ENVIRONMENTAL ASSESSMENT OF THE PROPOSED CRRRC

Response to Wallach - Critical Review of Geoscientific Component of TMES EA Final Version, February 2, 2015

Report Number: 12-1125-0045/13000

FIGURE 3-8

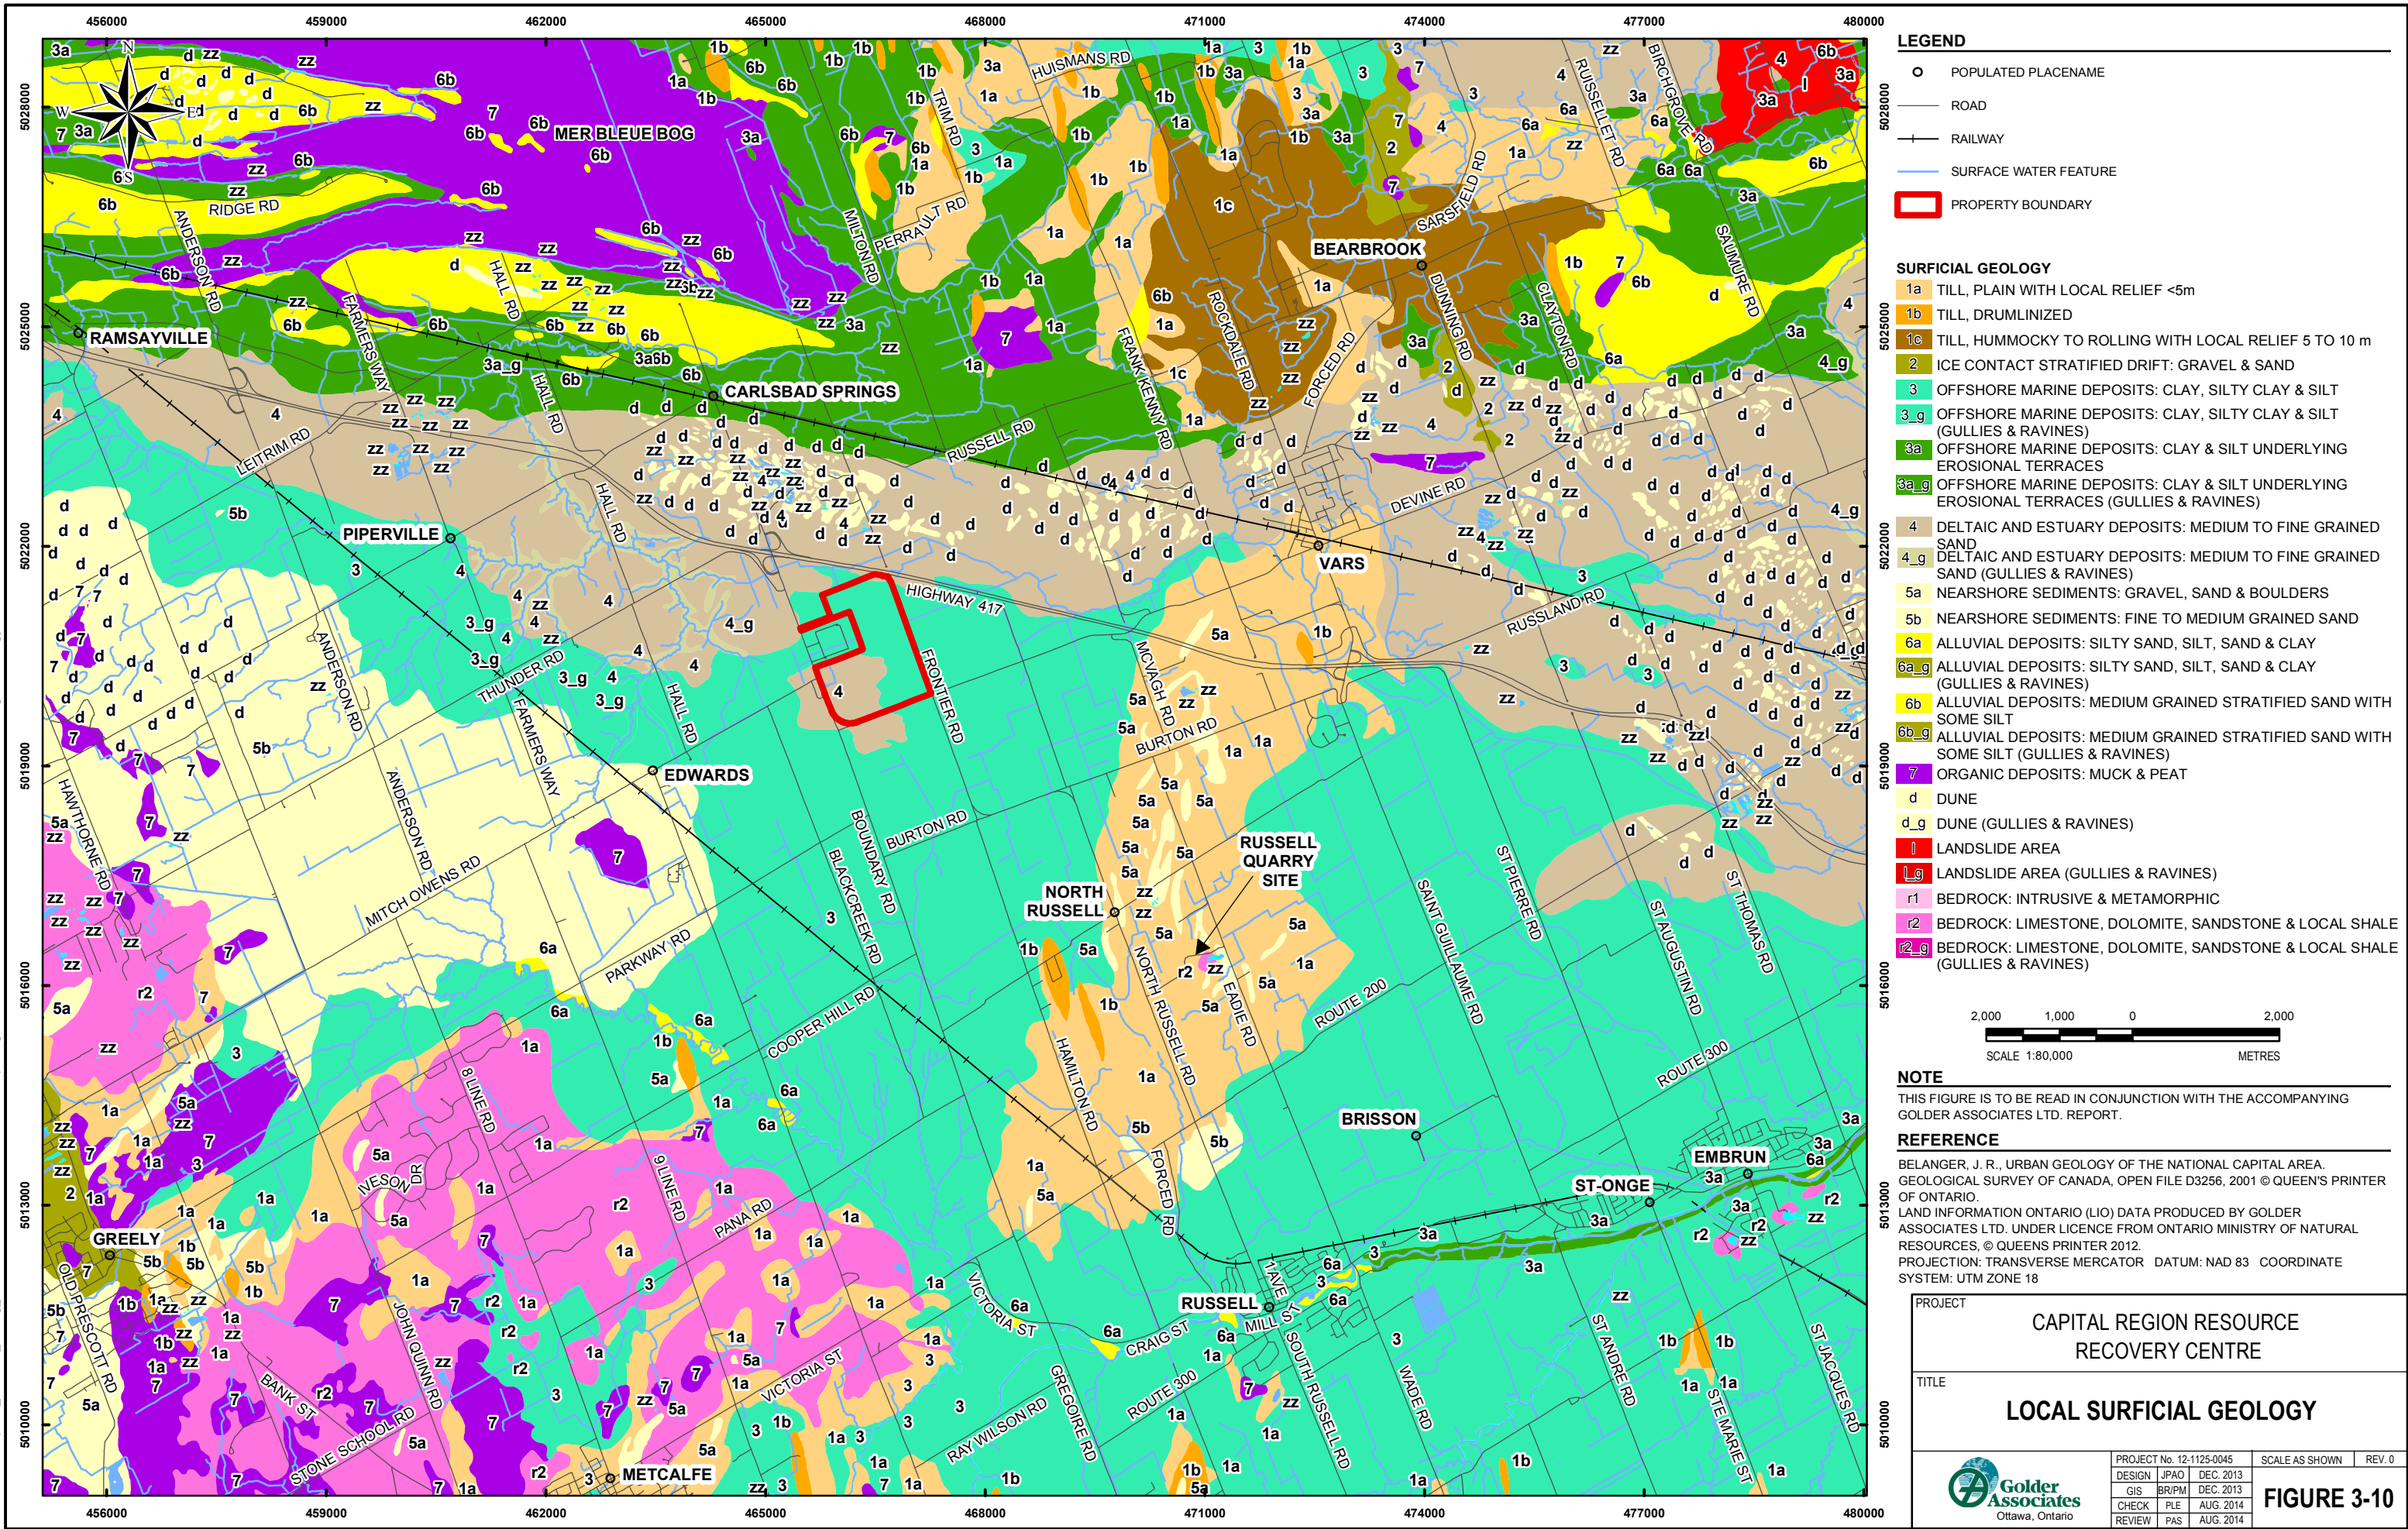
At the Russell Shale Quarry site, structure contours of the Carlsbad limestone caprock/Queenston Formation contact define a gentle synclinal fold as shown on Figure 3-8. The axis of the fold plunges gently westward at approximately 1% to 1.5% with inward sloping north and south limbs at approximately 2% to 3%. This open fold is probably a local fold developed within the overall synclinal structure defined by the Queenston shale sub-crop (the interpreted extent of which is shown on Figure 3-6), as well as the overall structure of the Ottawa Embayment. It is noted that all of the detailed borehole and geophysical testing information on which this interpretation is based is presented in TSD#1 of the EA, and was available to Dr. Wallach during his preparation of Wallach (2015). It appears that this information, which is the highest quality information available on the bedrock underlying “Cholowski Hill”, was not considered by Dr. Wallach and so the opinions in Wallach (2015) are based on information that he had compiled and interpreted in 2013 and earlier.

The data used in the EA study defining the contact between the Queenston and Carlsbad Formations in the Russell Quarry area were not publically available when Wallach (2014) was in preparation. With the benefit of this additional information, the postulated Wallach (2014) Carlsbad Formation surface elevation is not considered valid for the Russell Quarry Area. For example, at BH09-7 (see attached Figure 3-8), the Carlsbad Formation surface elevation is below 50 mASL. BH09-7 is located approximately 100 metres west of the interpreted “North Ridge Fault” shown in Wallach (2014) Figure 12 and in Wallach (2015), which presents a Carlsbad Formation elevation of 59 mASL, approximately 10 m above the projected contact elevation indicated on Figure 3-8.

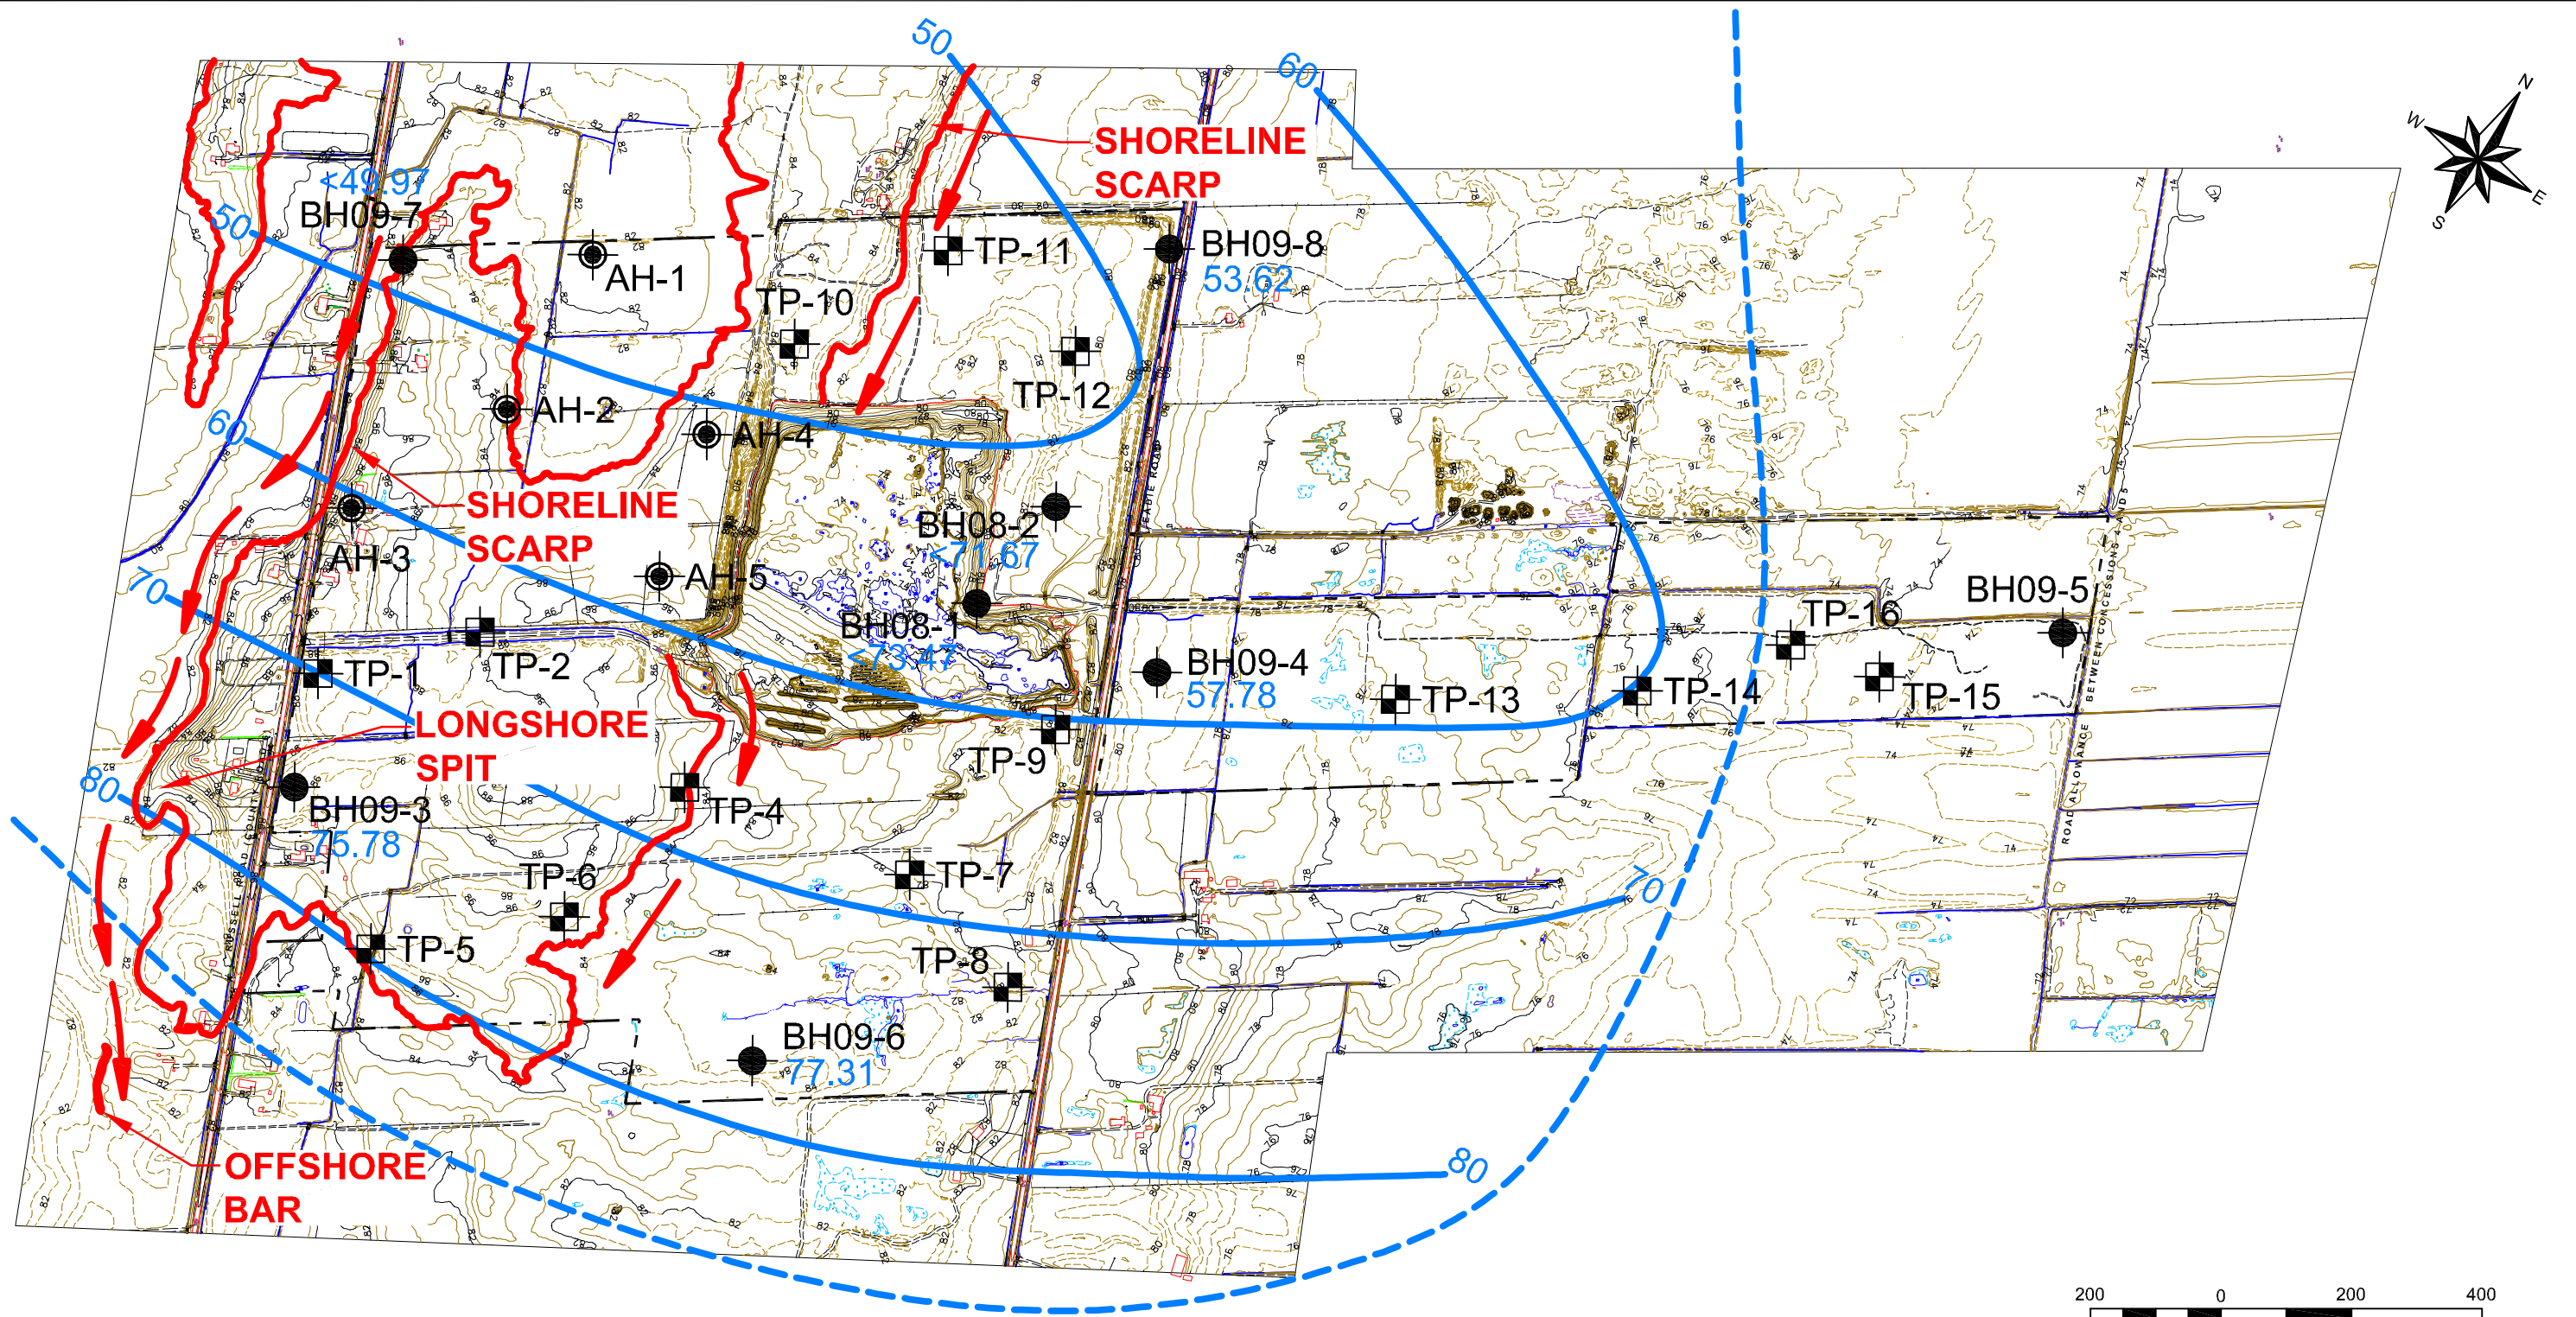
The linear scarp that defines the "North Russell Fault" is clearly visible from Russell Road. The scarp is shown on the attached Figure 4, and it can be traced for about 400 metres where it has an azimuth of about 350° (north- northwest). The scarp is apparent because of a steepening in slope of about 1.5 m to 3.0 m vertically within the otherwise sub-horizontal (near flat) terrain. The surface slope of the scarp is approximately 10% (2.5 metres to 3.0 metres vertical in 25 to 30 metres distance), while the slope of the surrounding terrain to the west is approximately 1%.

A second eastward-facing scarp mapped by Wallach (2014) and named the "East Ridge Fault" is located north of the Russell Quarry excavation. The scarp can be traced to the area directly southwest of the excavation (attached Figure 4). The toe of the scarp north of the quarry has an elevation of approximately 81.5 to 82.5 mASL with a crest elevation of 84 to 85 mASL. South of the quarry, the scarp becomes a very gentle (2%) slope. The topographic contours indicate that this scarp merges with the western scarp about 600 m southwest of the quarry excavation (Figure 4 attached). The terrain between the eastern and western scarps rises to elevations of 86 to 88 mASL.

The crest elevation of the scarp feature varies between about 85 m to 87 mASL, while the toe of the scarp occurs at an elevation of about 83 mASL. This break in slope can be traced southward approximately 400 m to the west side of Russell Road as is clearly defined by the contours (Figure 4 attached).

The western scarp and an associated clearly defined longshore spit feature at the southern end of the western scarp (North Russell Fault of Wallach (2014)) are consistent with a westward-facing paleo-shoreline formed by a relative sea level at about an 83 mASL elevation. Farther south, there is a distinct north-south orientated narrow feature approximately 120 metres in length and 10 to 15 metres wide occurring at elevations between 81.0 and 82.5 mASL. This topographic feature has a distinct form suggesting its origin as an offshore bar, which would have developed in close association with the sea scarp farther east. Similarly, the eastern scarp is consistent with an eastward-facing paleo-shoreline formed at the same 83 mASL elevation along what was formerly a low island relief between the eastern and western scarps. The geomorphology of these features is consistent with a southward-flowing longshore drift current within a recessional phase of the Champlain Sea, where Cholowski Hill locally became a north-south orientated small island that protruded above the paleo sea level. Considering that the till moraine soil beneath the area is dominantly silt and clay with few gravel clasts, current and wave erosion may have left the former shoreline scarps with minimal beach sands and gravels. These features are illustrated on the attached Figure 4.

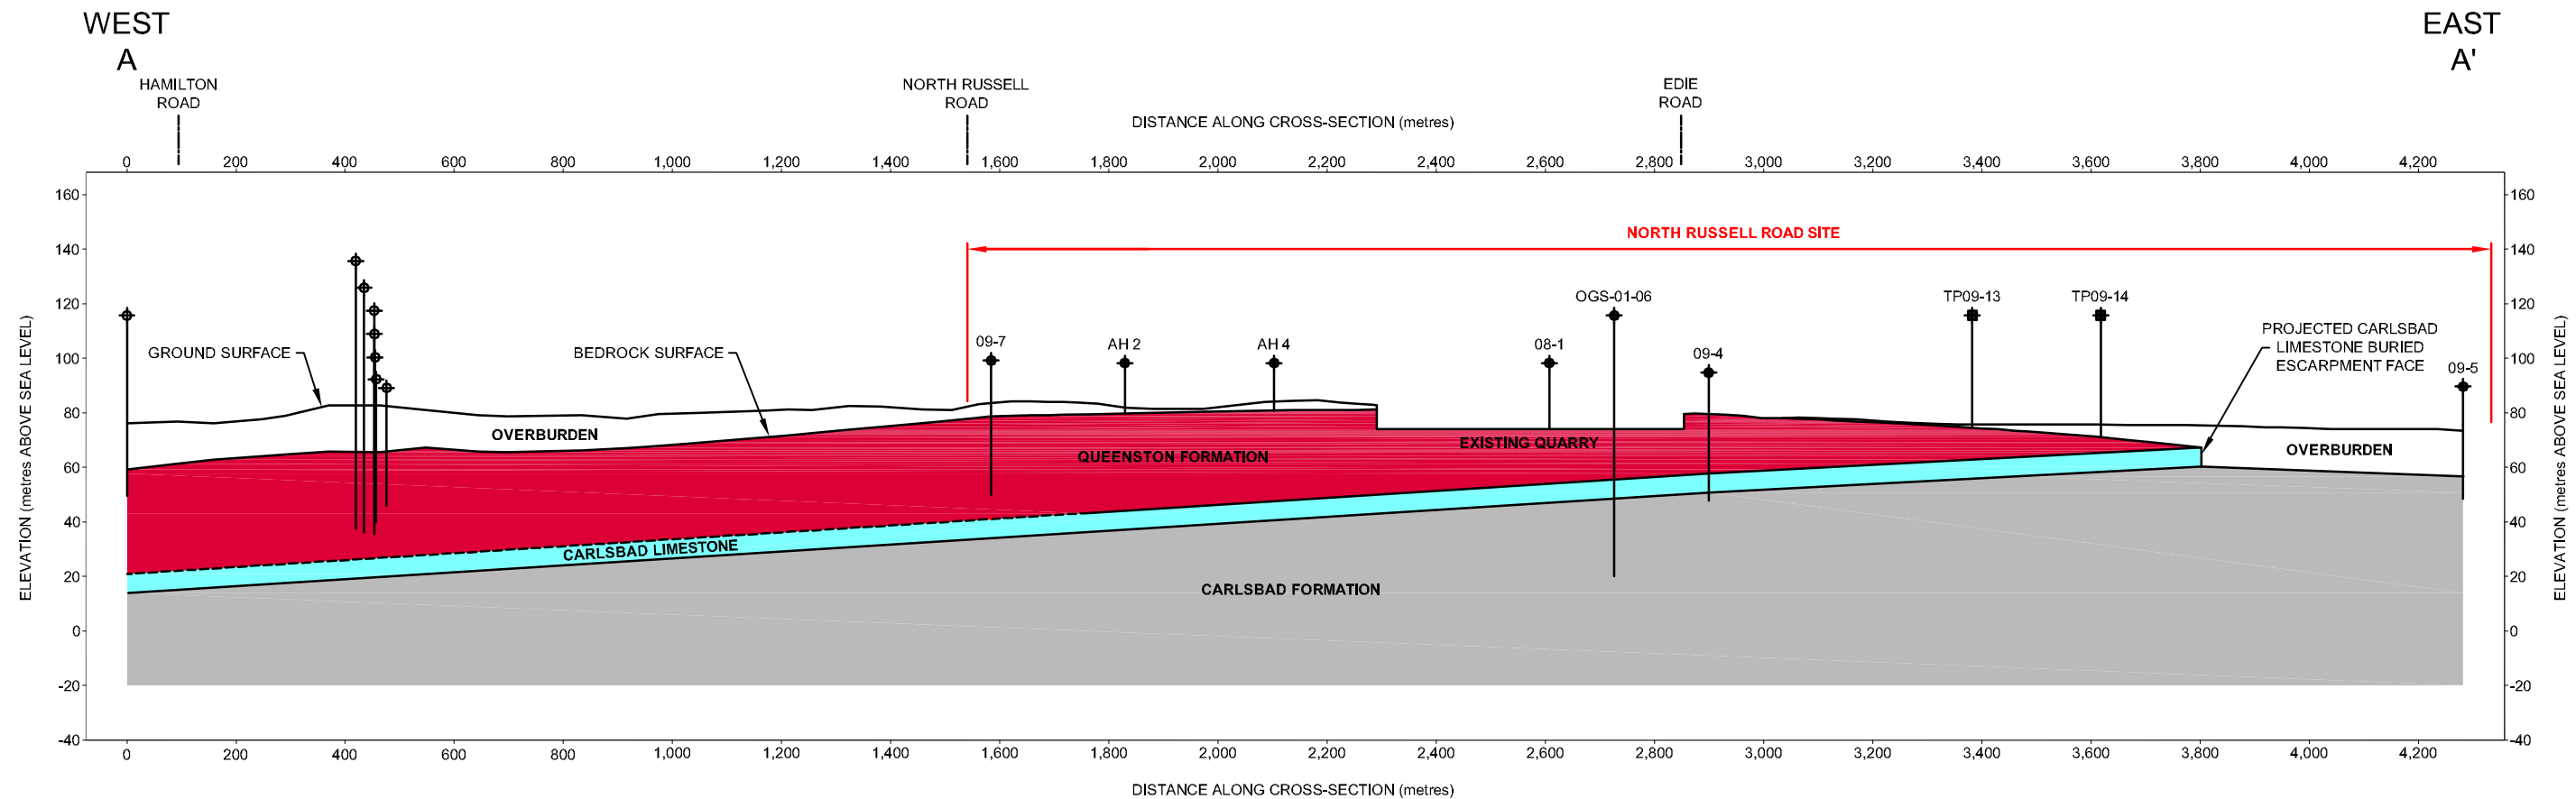
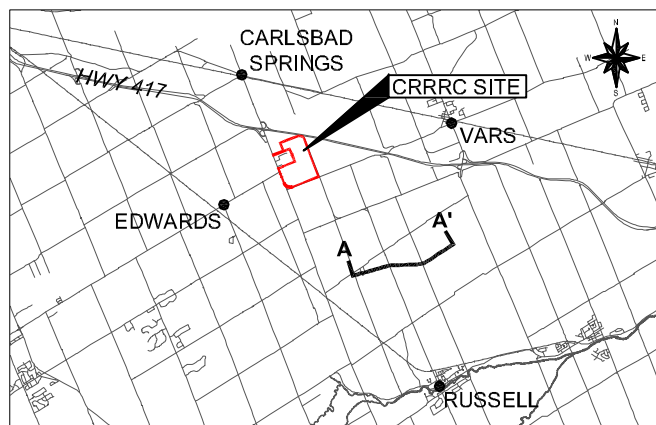
As discussed in Sections 2.1.3.2 and 2.1.3.3 of this report, the bedrock elevation offsets on the Wallach (2014) cross-section C-D on Figure 15 (a west-east oriented cross section across Cholowski Hill a little north of the Russell Quarry) were interpreted in the central portion of the figure based on inappropriately used “code 9” water well data. With this well data removed from the section, no data exists to support the interpreted faults (i.e., the North Russell and East Ridge faults interpreted to exist and named by Dr. Wallach) illustrated on Figure 15 of Wallach (2014) and on Figure 7-2 and Figures 9 and 11 of Section C Letter #1 of Wallach (2015).

The attached Figure 5 provides a west-east cross-section through the Russell Quarry site. It is based on subsurface information from the borehole drilling program conducted by Golder Associates at the quarry site and accurate topographic information. Figure 5 has a low (only 5 times) vertical to horizontal scale exaggeration to better illustrate the very subtle surface topography of Cholowski Hill and surrounding area and the dip (slope) of the bedrock formations. Contrary to Figure 15 in Wallach (2014), the section illustrates the continuous presence of the uppermost Queenston Formation shale across the hill and to the west, as well as the termination of the Queenston Formation approximately 1 km to the east of Eadie Road. It also shows the presence of the Carlsbad limestone caprock encountered at the Queenston – Carlsbad contact and the inferred scarp feature that will occur where the limestone intersects the bedrock surface. The investigations and interpretations of subsurface information do not indicate or require the presence of faulting in the bedrock across the hill.
